DOCKETED	
Docket Number:	23-OPT-01
Project Title:	Fountain Wind Project
TN #:	251208
Document Title:	FountainWind_AQresponses_07272023
Description:	N/A
Filer:	Caitlin Barns
Organization:	Stantec Consulting Services, Inc.
Submitter Role:	Applicant Consultant
Submission Date:	7/27/2023 1:33:06 PM
Docketed Date:	7/27/2023

**Fountain Wind Project Response to CEC Data Requests AIR-013 and -014
July 27, 2023**

Figure 1. AERMOD dispersion modeling, Fountain Wind, 24 Hour PM10 Results

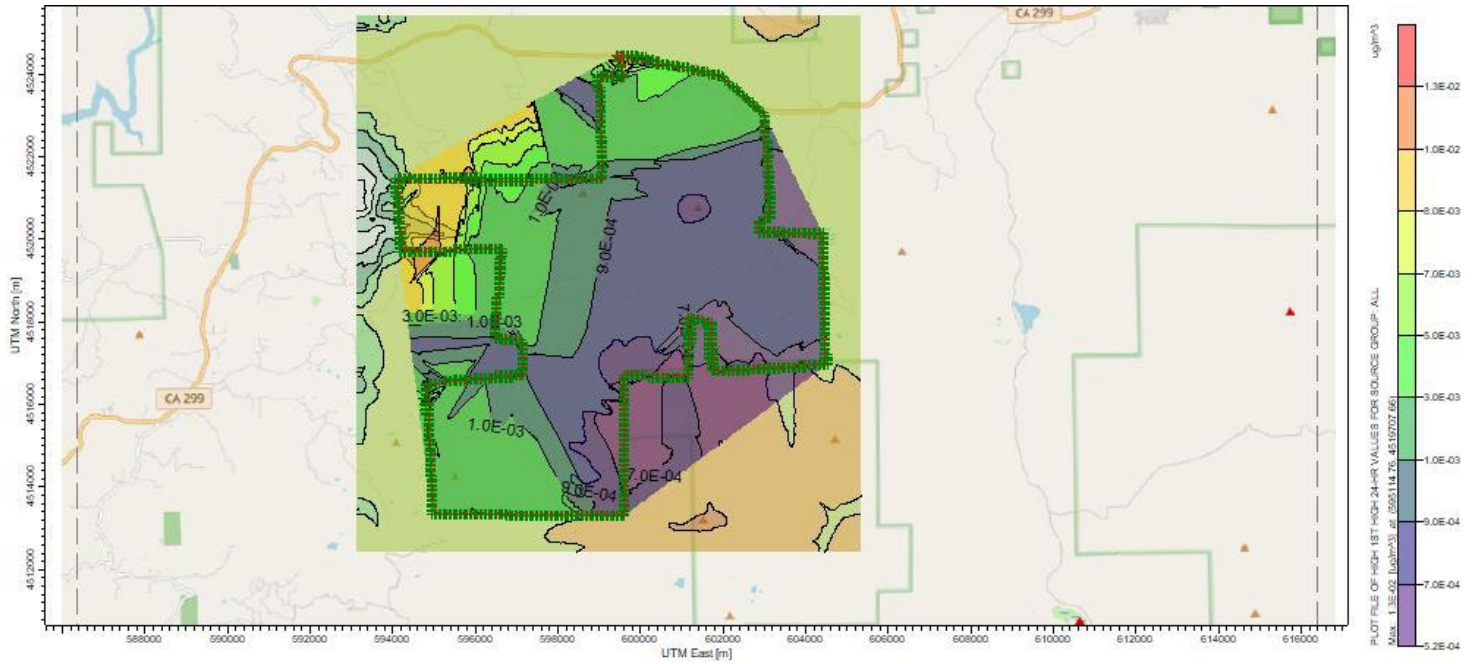
1. **CEC RESPONSE:** The response is insufficient. Specifically, project PM10 emissions during construction would exceed Shasta County AQMD thresholds of significance. Data provided (TN 250818) shows PM10 for year 1 as 433.15 pounds per day. The Shasta County significance thresholds are 80 lb/day for Level A and 137 lb/day for Level B. The 2003 Shasta County protocol indicates that emissions exceeding the thresholds should be evaluated for potential violation of ambient air quality standards using dispersion modeling. Applicant may choose to use screening models or a refined analysis, as needed.

STANTEC RESPONSE: Ambient air quality analysis was prepared for Year 1 PM10 emissions with USEPA AERMOD dispersion modeling. AERMOD was used to estimate the concentration of PM10 emissions at the site boundary, all receptors were placed at the default assumption of zero meters above ground level. The site was modeled as an area source with construction PM10 emissions from Year 1 dispersed uniformly across the site using meteorological data from Redding Municipal Airport from 2017-2021. The meteorological data was pre-processed through CARB.

As shown in the table, the ambient concentration of 24-hour PM10 would not exceed NAAQS and annual average PM10 would not exceed CAAQS. However, the ambient concentration of 24-hour PM10 will exceed CAAQS.

The background concentration at the Shasta Lake Monitoring Station already determined that the maximum 24-hour concentration in 2021 more than doubled the CAAQS. As such, even without the Project, the area would exceed the 24-hour PM10 CAAQS. The Project would only contribute 0.012% of the total background concentration. This addition is negligible compared to the existing background levels of pollution. Moreover, the Project would only contribute this amount of PM10 during the first year of construction. PM10 emissions would decrease during Year 2 of construction and through operation. Project construction would follow all air district rules and regulations as well as a series of mitigation measures aimed at reducing PM10 to the maximum extent possible to reduce its impact to the area.
